Project # 25036 (MKM), 2509-276 (Hafer) – EVPL Red Bank Library
New Construction / 120 S. Red Bank Road, Evansville, IN 47712

ADDENDUM No. 2

June 24, 2026

DRAWING CONTENTS:
CURTAIN WALL SUPPORT
AND INTEL PLAN

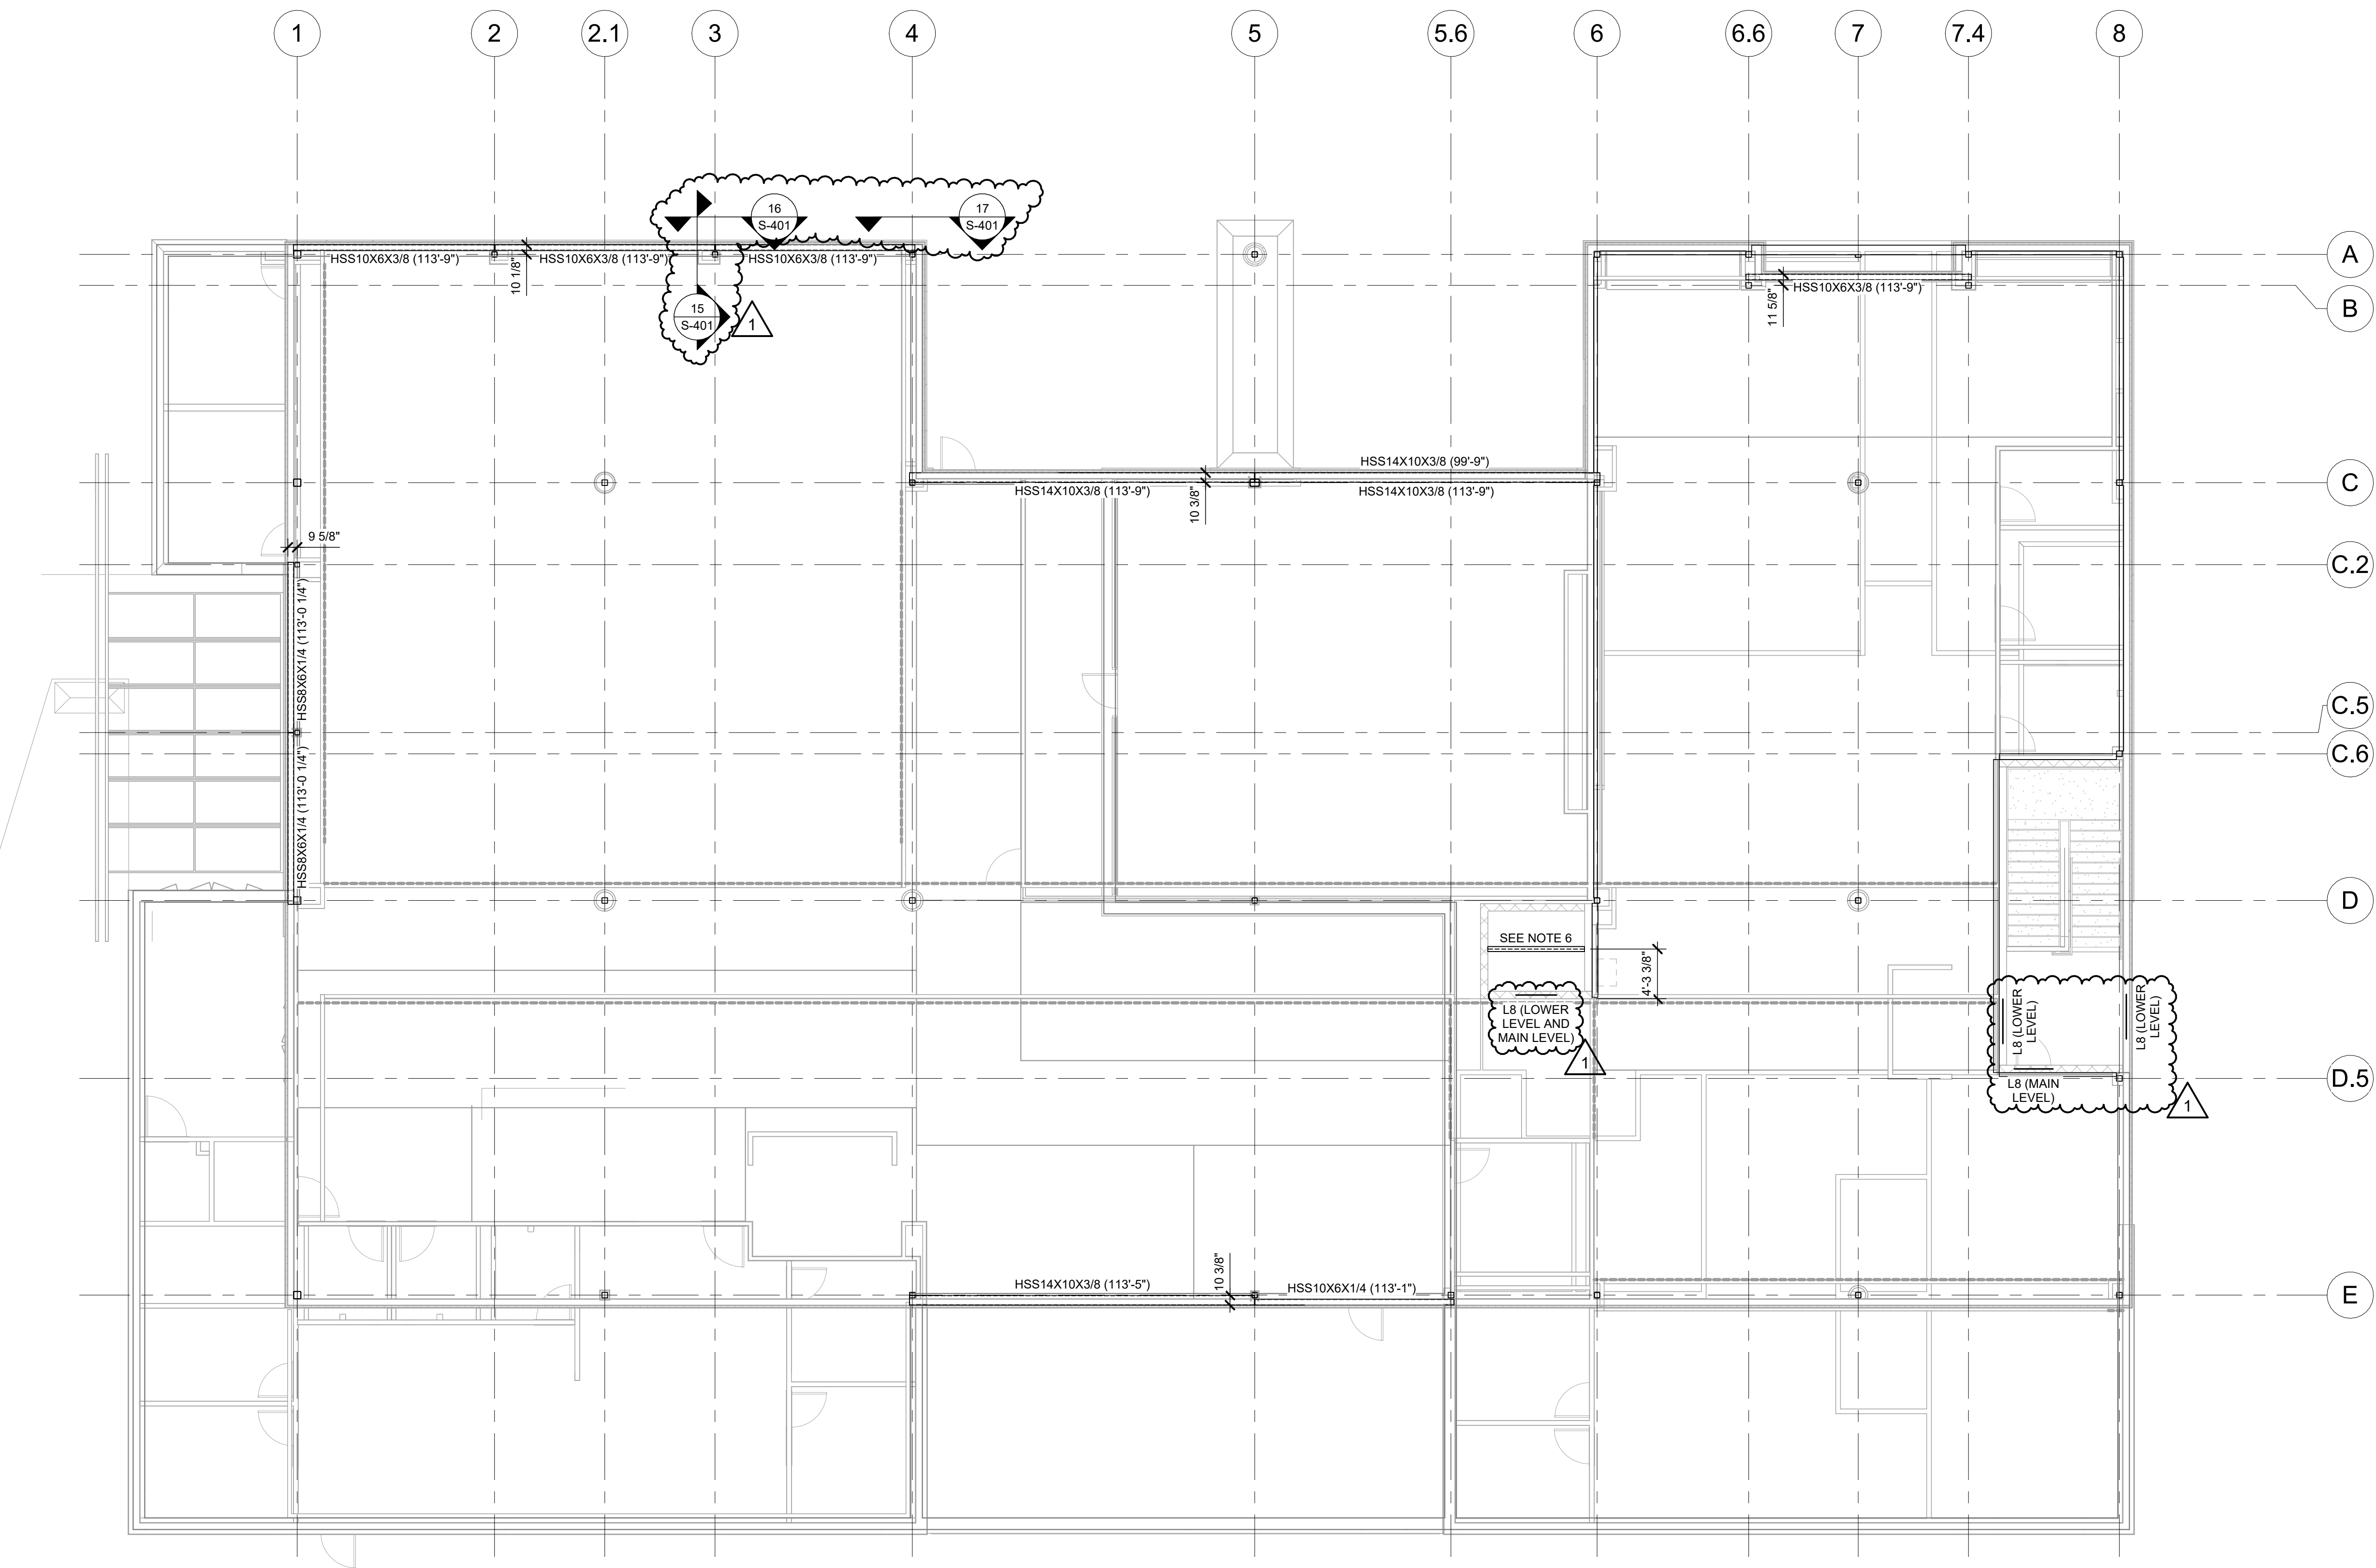
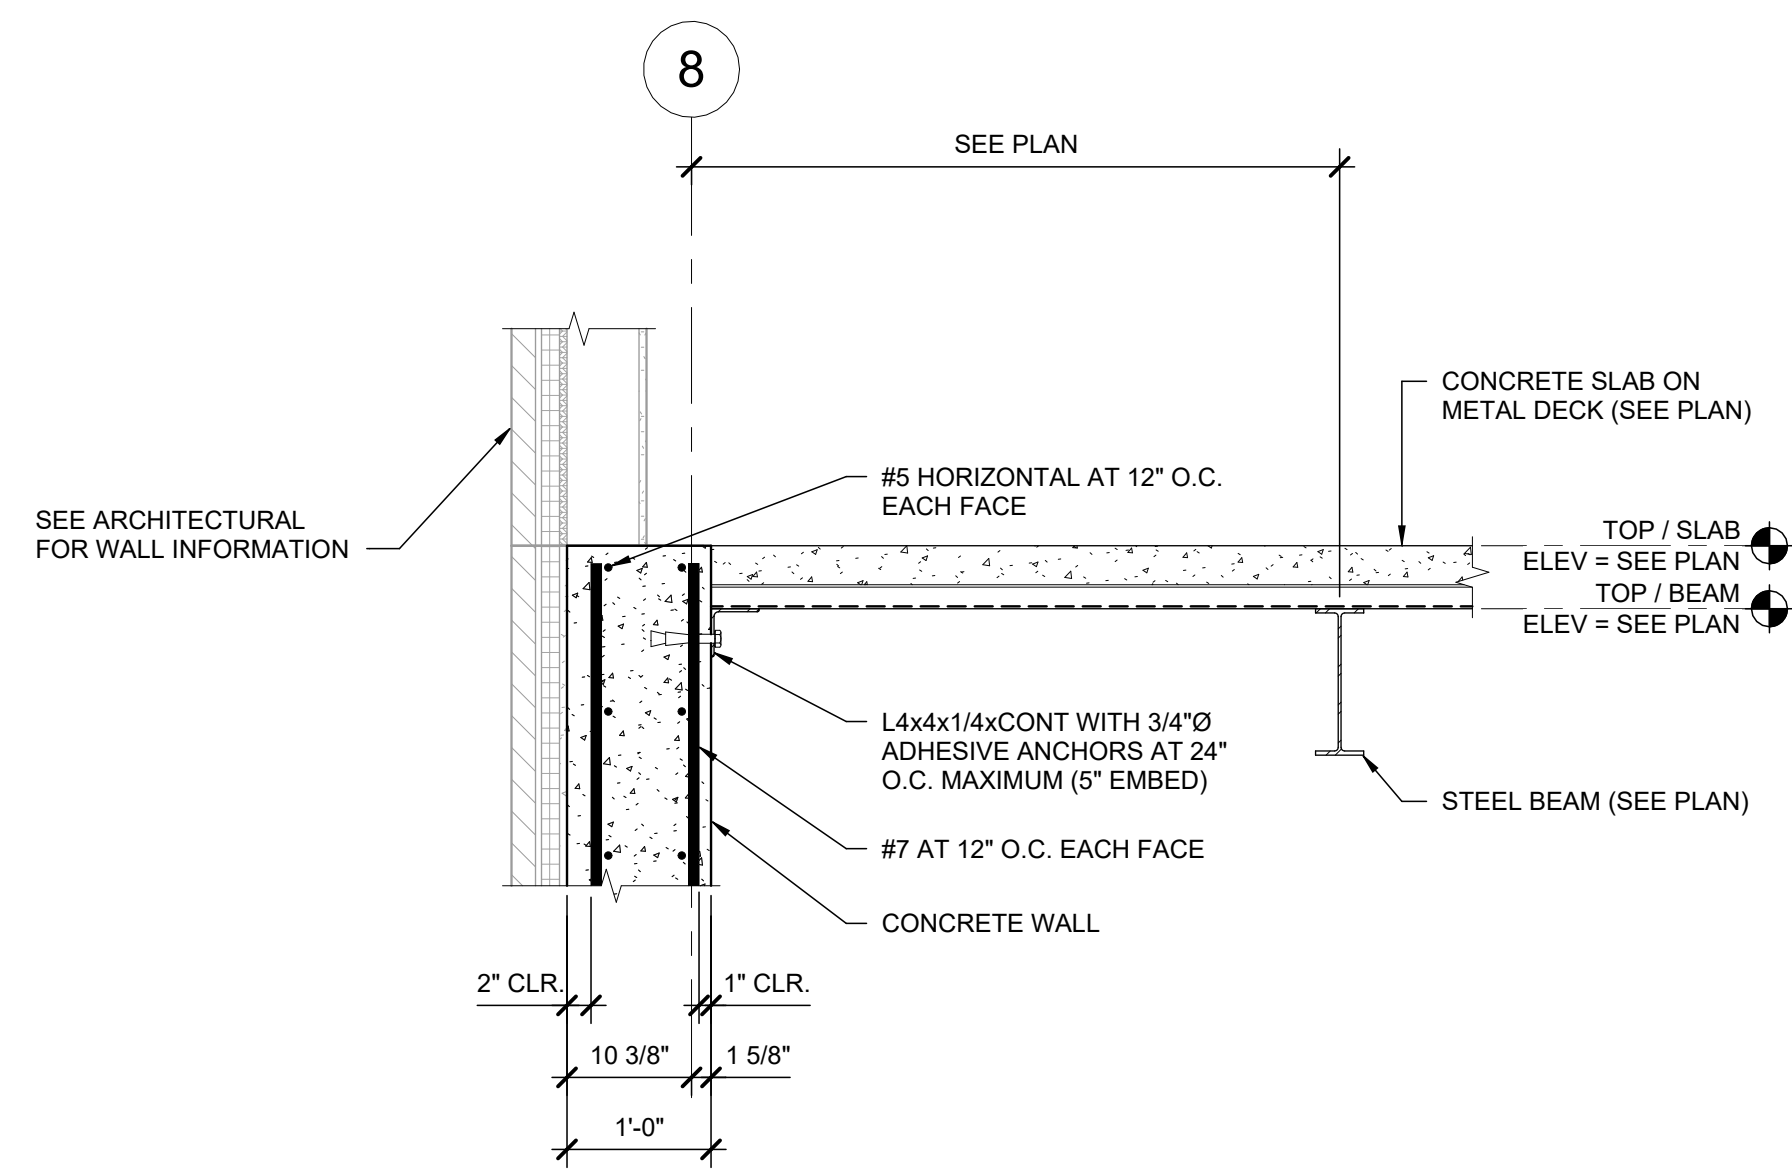
- oo. Question: Please provide the required connection details for the HSS curtain wall support members shown on Drawing S-105.
- pp. Answer: Additional information has been included on Sheet S-105 and Sheet S-401; Sections 15, 16, and 17 included within this Addendum.

- g. **Sheet – S-105 – CURTAIN WALL SUPPORT AND LINTEL PLAN**
 - i. Clarification: Revised Plan Note #4
 - ii. Addition: Added Pan Note #7
 - iii. Clarification: Added CMU Lintels to plan (details to be provided in future Addendum)

- iv. Addition: Added Sections 15/S-401, 16/S-401 and 17/S-401 to clarify curtain wall support beam connections.
- h. **Sheet S-401 – FRAMING DETAILS**

11 SECTION
S-104 / SCALE: 3/4" = 1'-0"

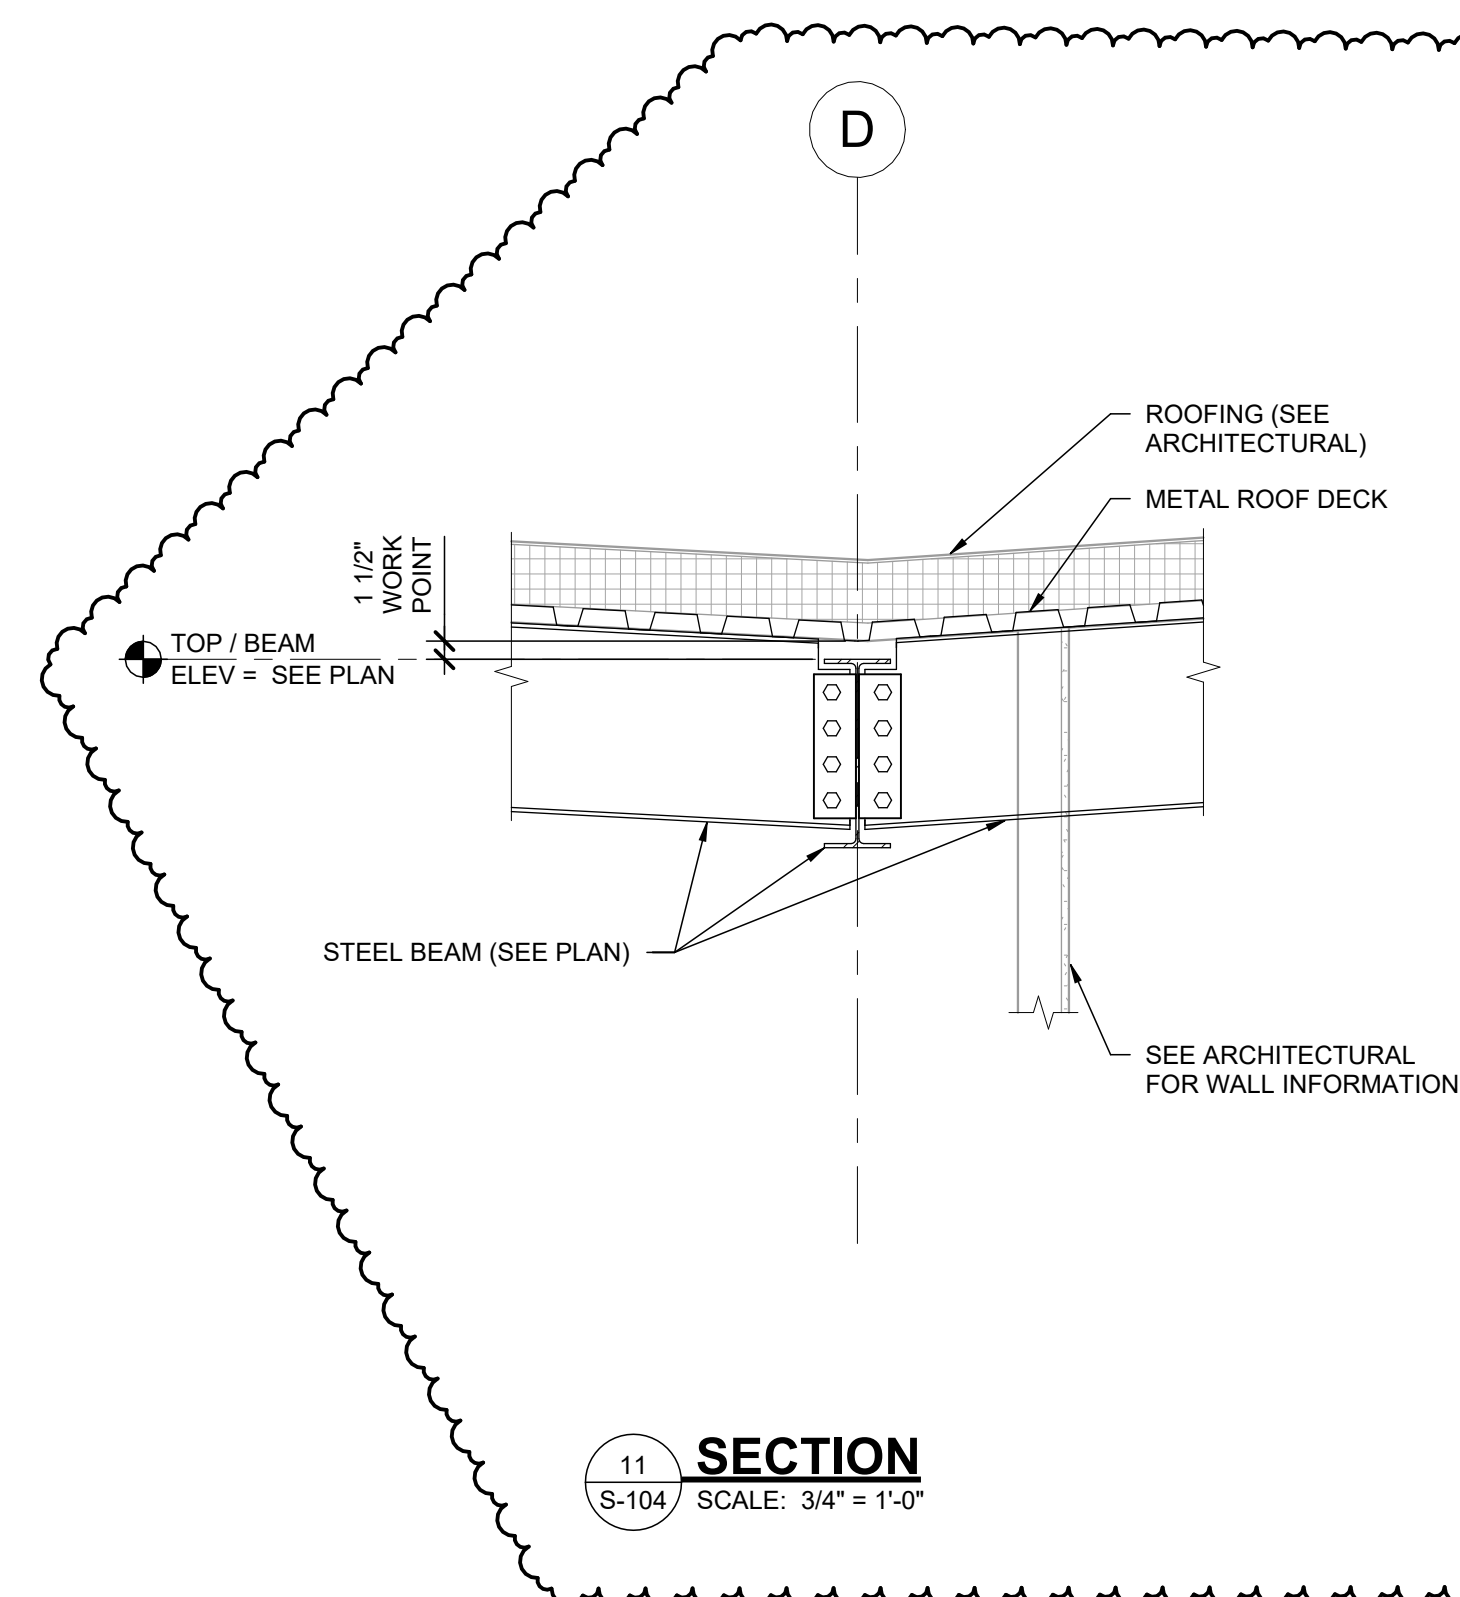
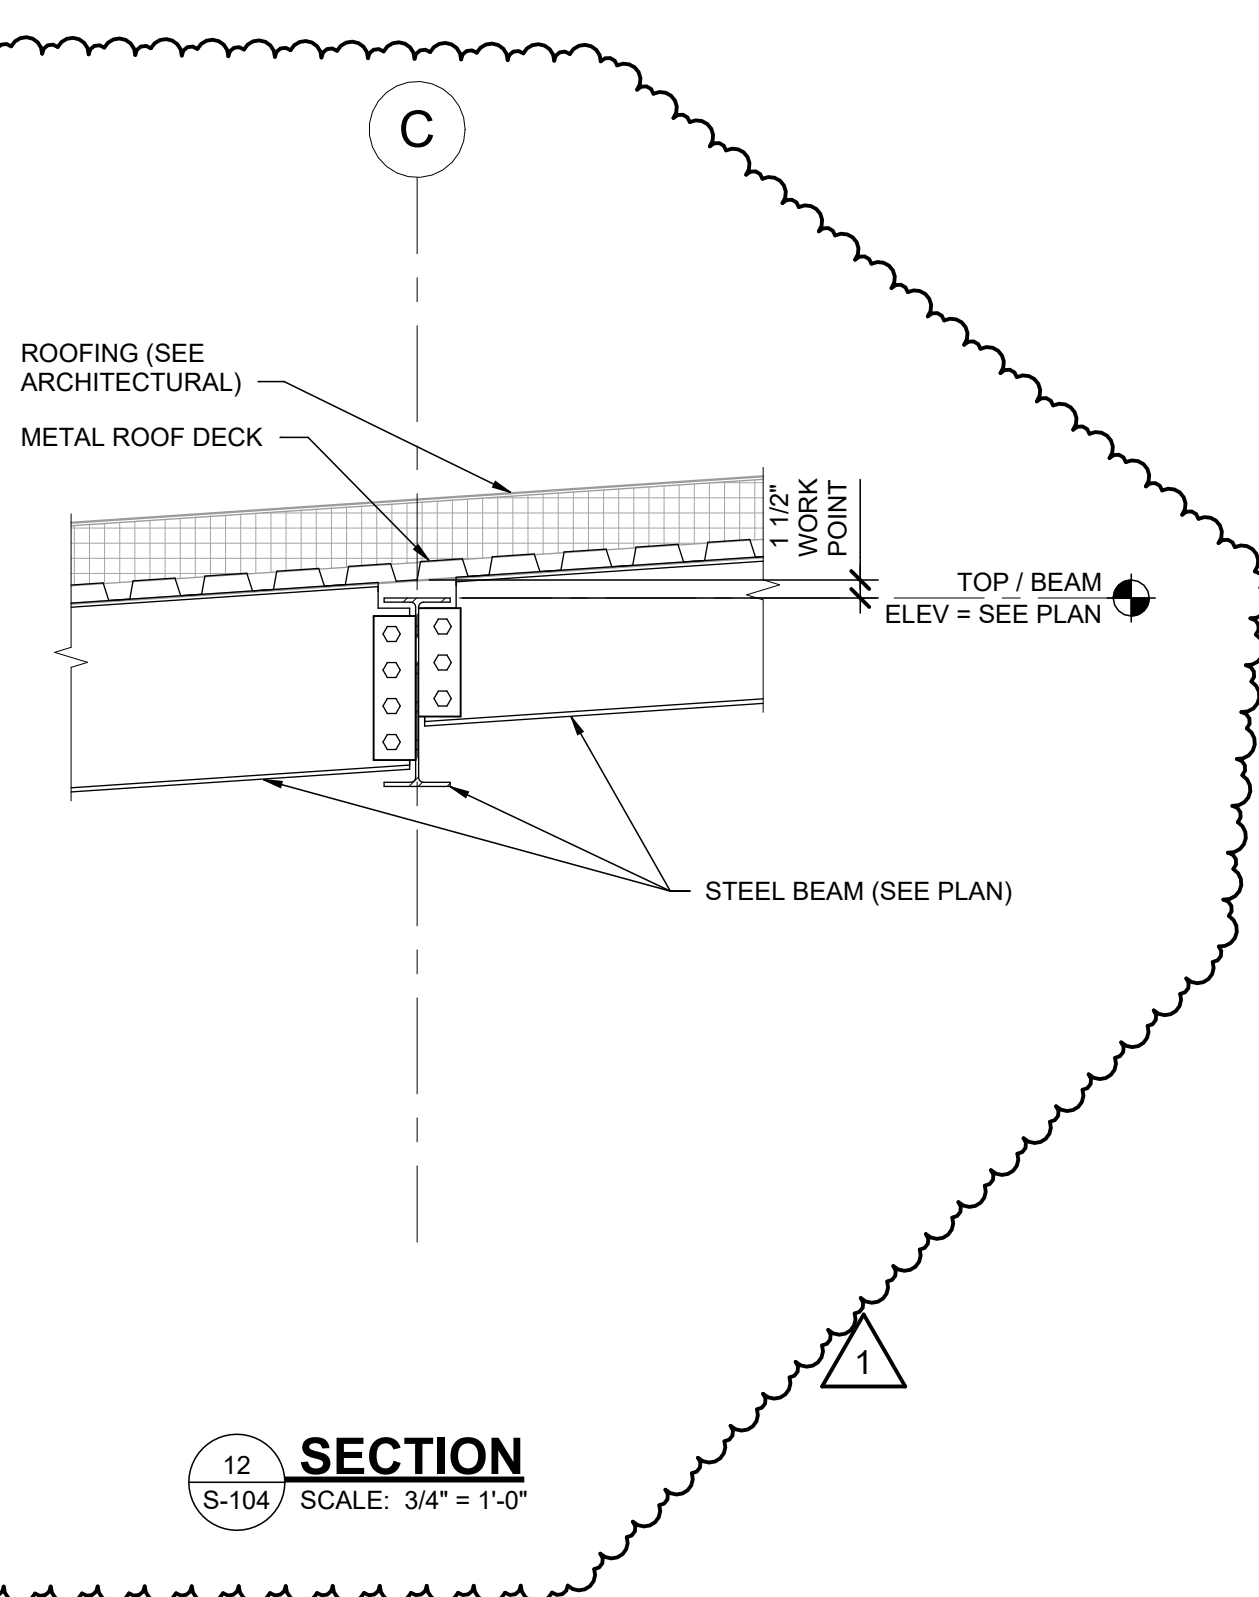
- i. Addition: Added Sections 11 through 17
- i. **Sheet S-402 – FRAMING DETAILS**
 - i. Addition: Added Sections 11 and 12
- j. **Sheet L-100 – SITE MATERIALS PLAN**

- iii. Addition: Added Section 14/S-401 to show top of column condition at wind columns.
 - iv. Addition: Added Sections 11/S-402 and 12/S-402 along grid lines D and C to clarify top of beam elevations.
